STATE OF HAWAII DEPARTMENT OF TRANSPORTATION HIGHWAYS DIVISION MECHANICALLY STABILIZED EARTH RETAINING WALL (MSERW) TYPICAL SECTION AND DETAILS KAHKILI HIGHWAY WIDENING Likelike Hwy. to Vicinity of Haiku Road F.A. PROJECT NO. NH-083-1(26) SCALE: AS NOTED DATE: APRIL 1994 SHEET No. W1 OF W21 SHEETS	
--	--

AS-BUILT ADD. 114

KAHEKILI HIGHWAY WIDENING
Likelike Hwy. to Vicinity of Haiku Road
F.A. PROJECT NO. NH-083-1(26)

**PLAN AND PROFILE
 MSERW NO. 7**

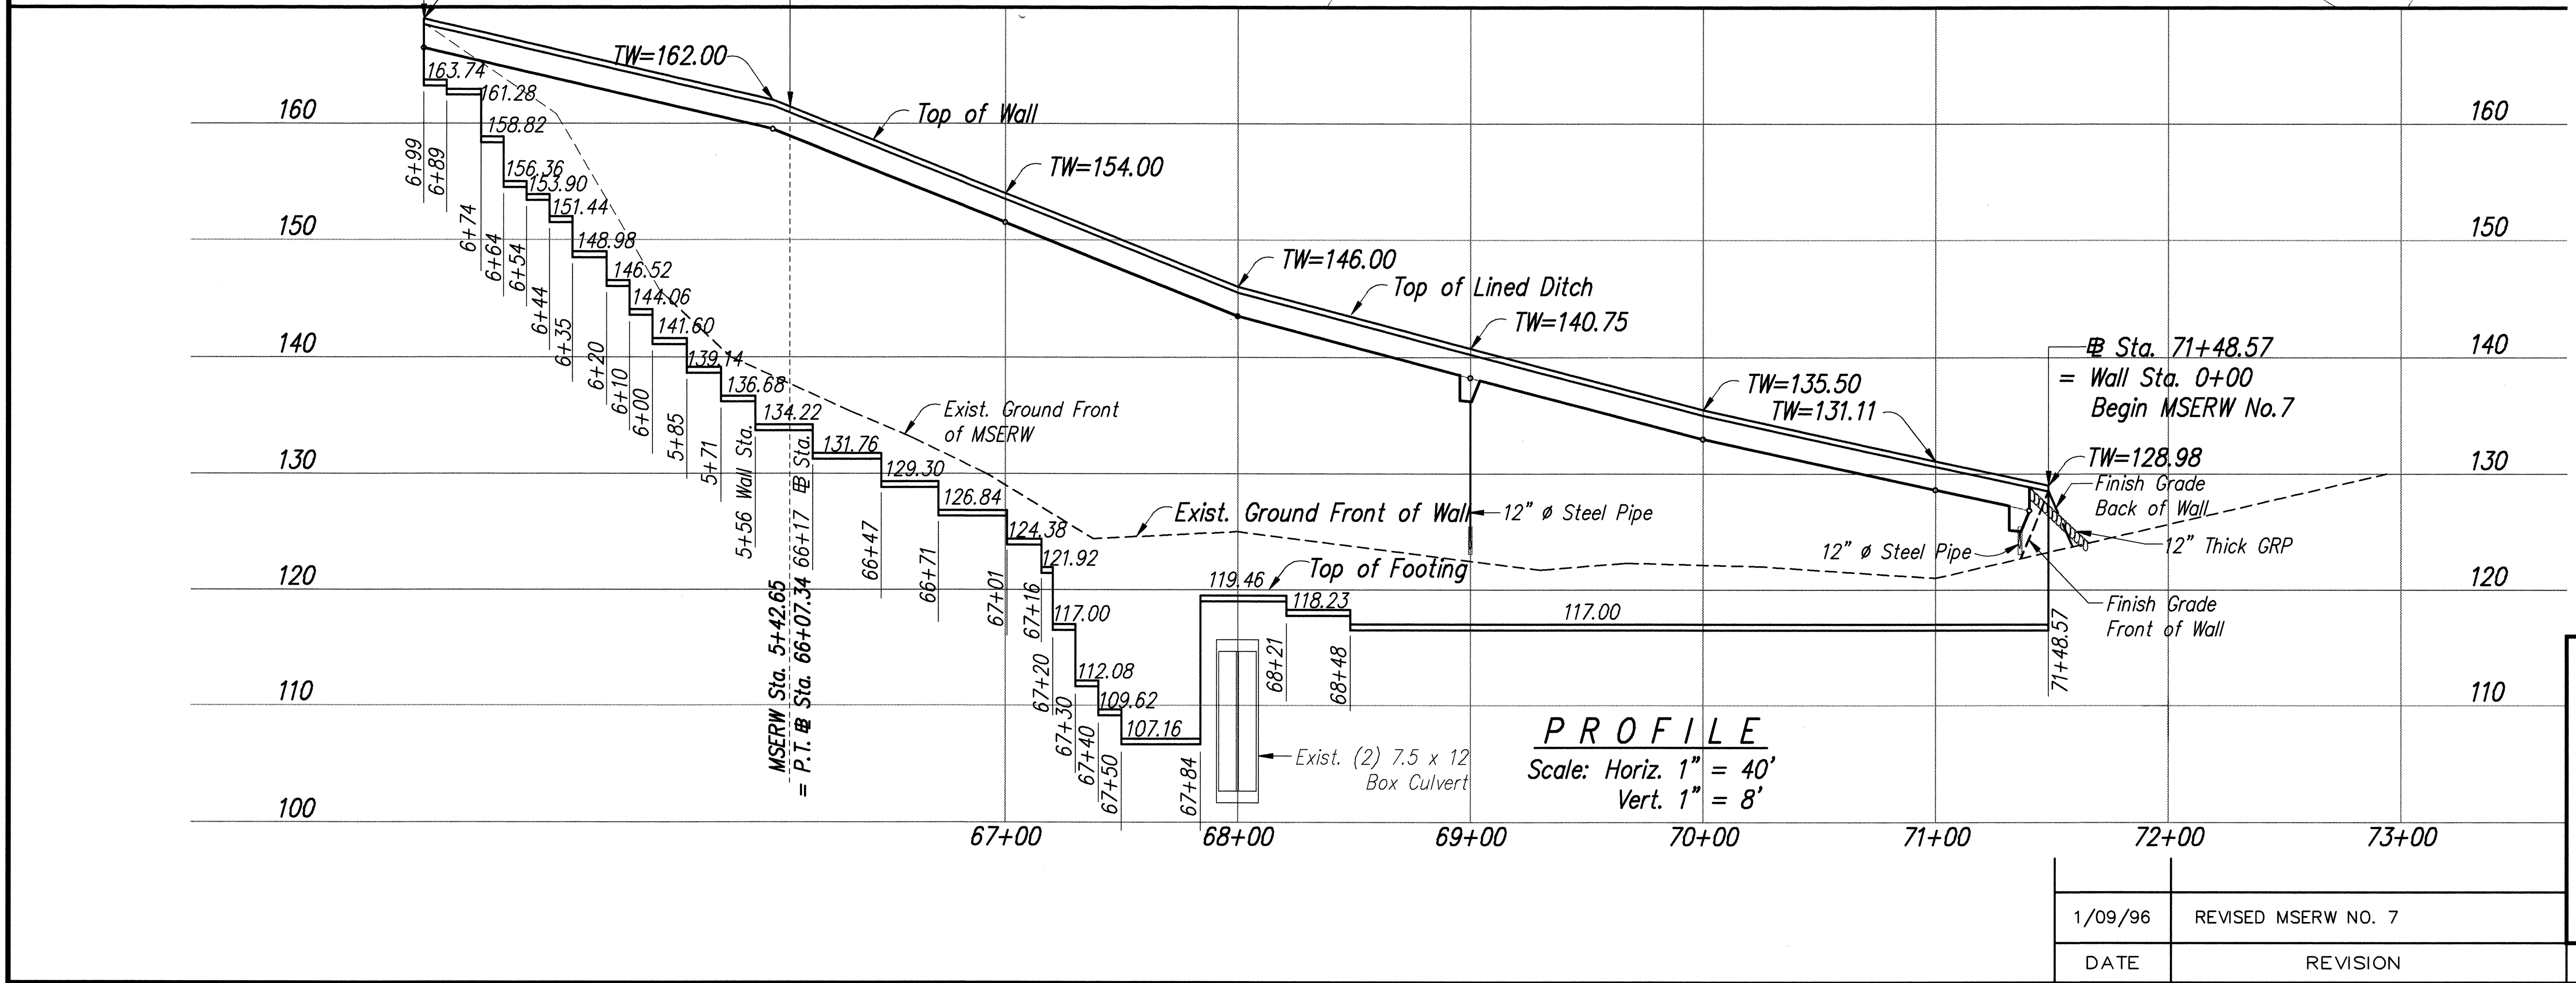
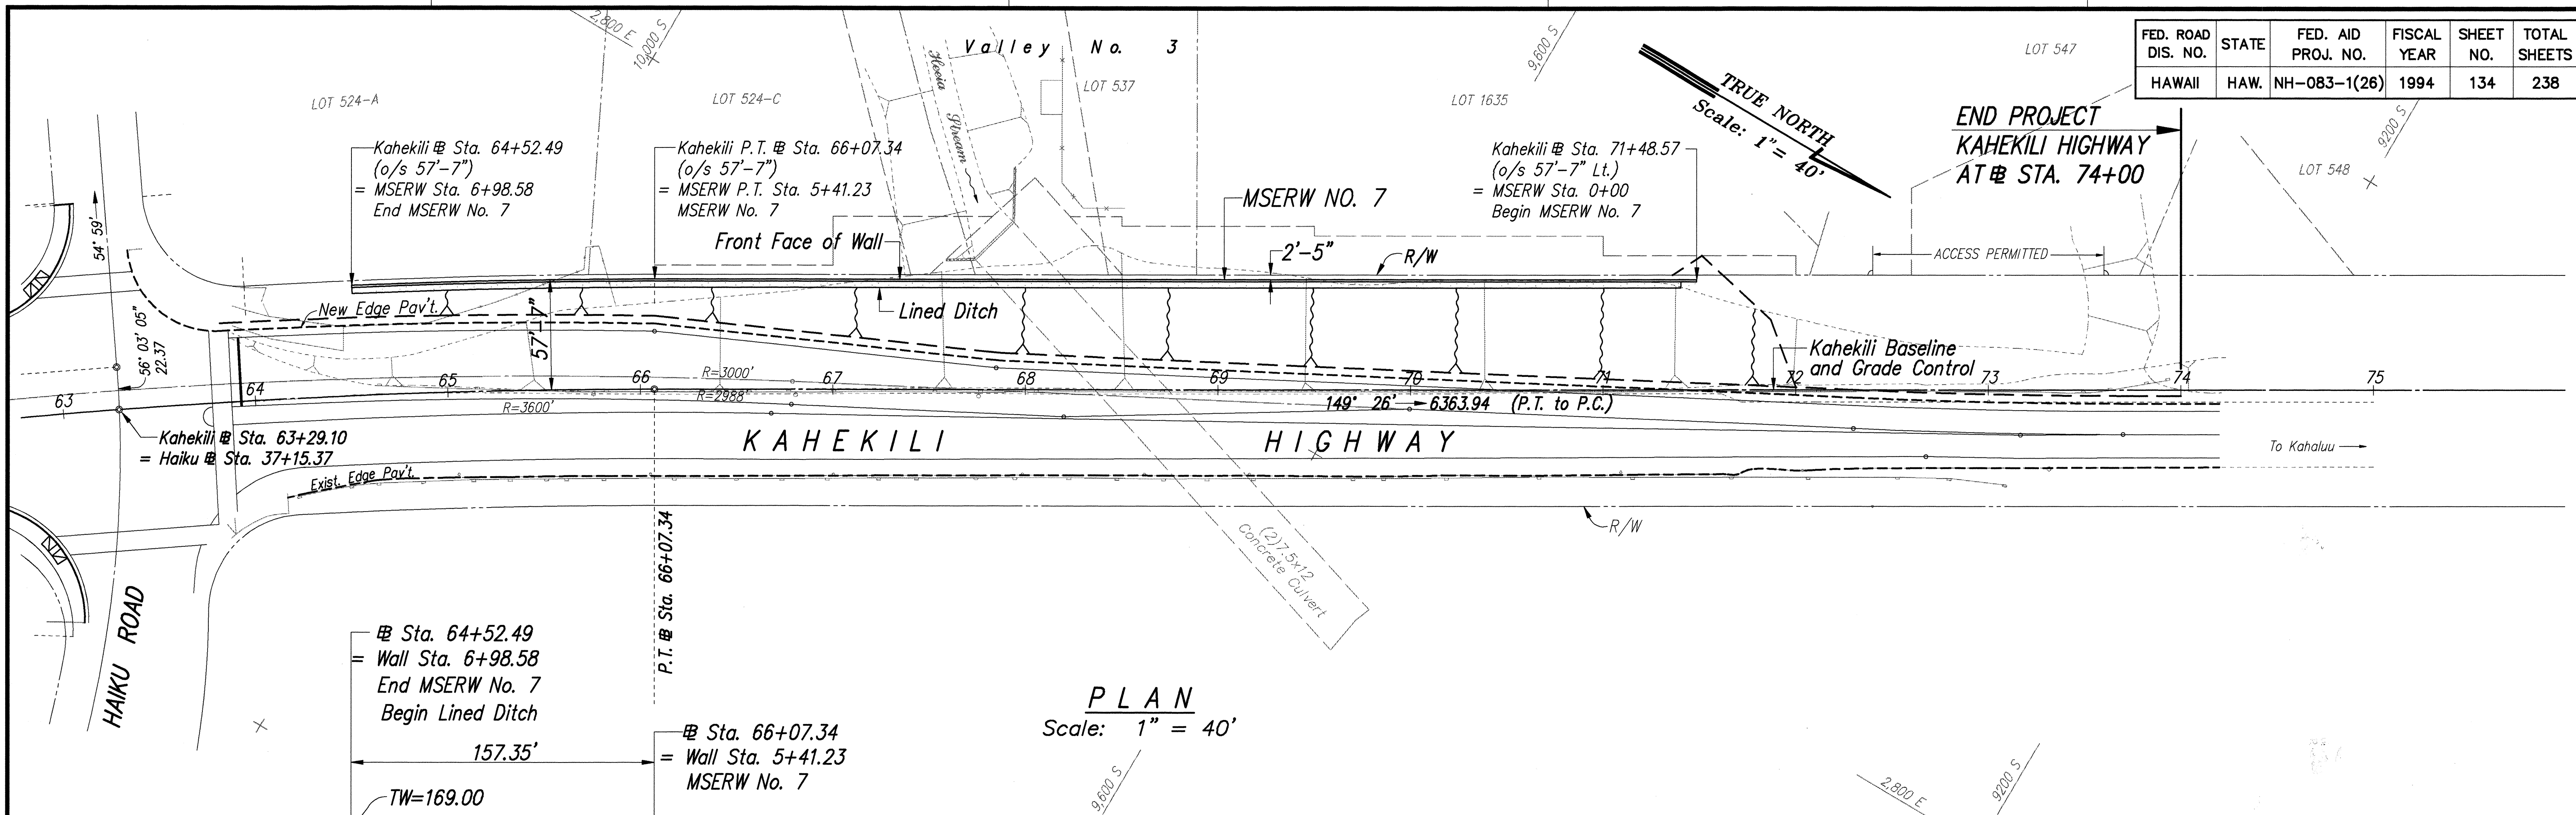
DATE	REVISION
1/09/96	REVISED MSERW NO. 7
